IMPORTANT PRODUCT UPDATE

Date: 02/22/21
To: DCA20SPXU4F, DCA25SSIU4F, DCA36SPXU4F and
DCA45SSIU4F Owners
From: Multiquip Product Department
Subject: Control Panel Warning Lamp — **ACTION REQUIRED**

Generator Warning Lamp Countermeasures

Product Group: Power Solutions	Date Issued: 02/22/21	Expiration Date: 02/22/22	Bulletin No. GSP20210208
------------------------------------------	---------------------------------	-------------------------------------	------------------------------------

Figure 2. Installation Procedure

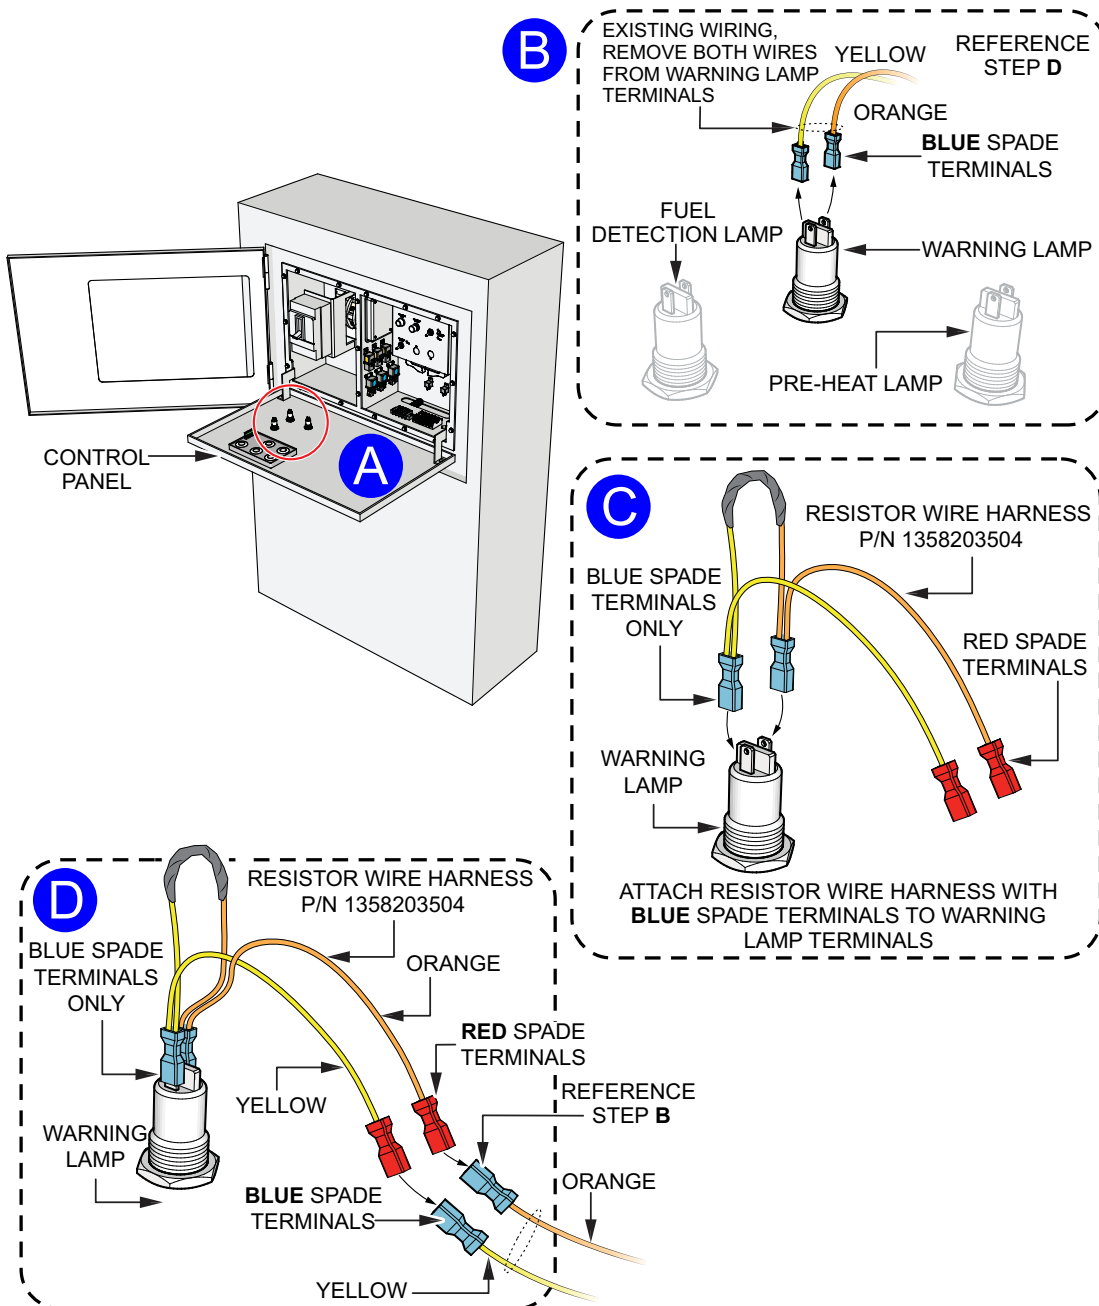
Before proceeding, visually inspect generator and verify if **Resistor Wire Harness** is already installed. Reference Figure 2D. If wire harness is installed, no further action is required.

3. Remove the two wires attached to the Warning Lamp (**BLUE** terminals) as shown in Figure 2B.
4. Next, attach the two wires with **BLUE** spade terminals from Resistor Wire Harness (P/N M1358203504) to the Warning Lamp terminals as shown in Figure 2C.
5. As referenced in Figure 2D, attach the two wires with **RED** spade terminals from Resistor Wire Harness to the two wires with **BLUE** spade terminals that were removed in Figure 2B. Be sure to **match** the wire colors.

1. Loosen thumb screws securing control panel to the generator frame.
2. Lower control panel (Figure 2A) to access wiring connections.

Figure 3. Generator Control Panel (Warning Lamp)

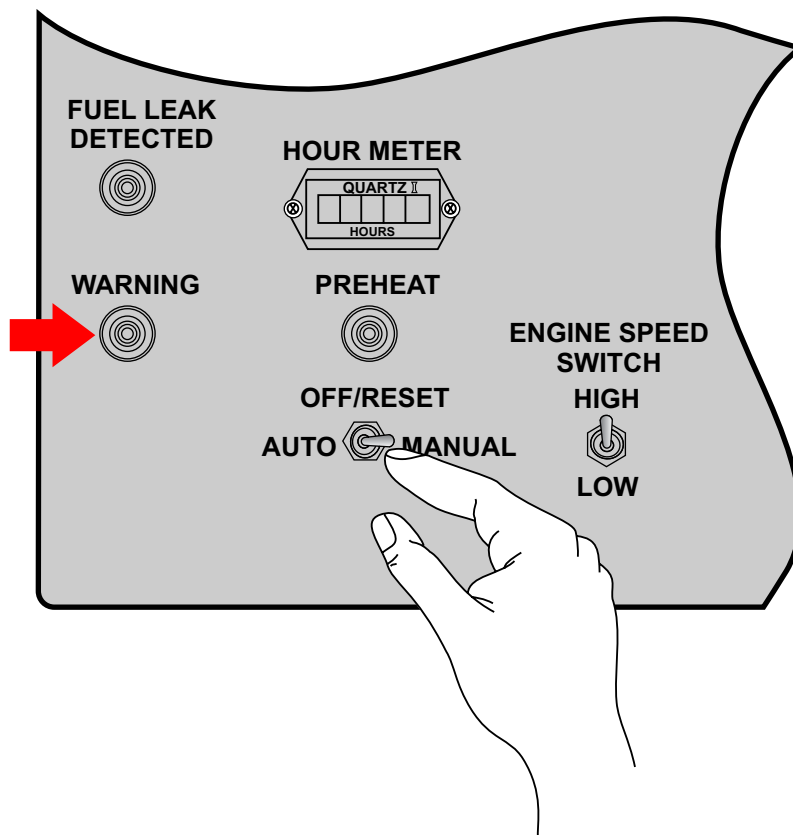
1. With the engine **OFF**, place the **OFF/Reset** switch (Figure 3) in the manual position to start the engine.
2. Verify **Warning Lamp** on the control panel comes **ON** (lit) for 3 seconds while the engine is cranking.
3. After 3 seconds verify that **Warning Lamp** is **OFF**.
4. Place the **OFF/Reset** switch back to the **OFF** position to shut down the engine.

If the warning lamp remains lit after 3 seconds, insure no faults are present. If a fault is present, that fault must be cleared before the warning lamp will turn off. Consult your Operations manual for further steps on clearing faults or contact **Multiquip's Technical Support Team @ 1-800-421-1244 for additional assistance.**
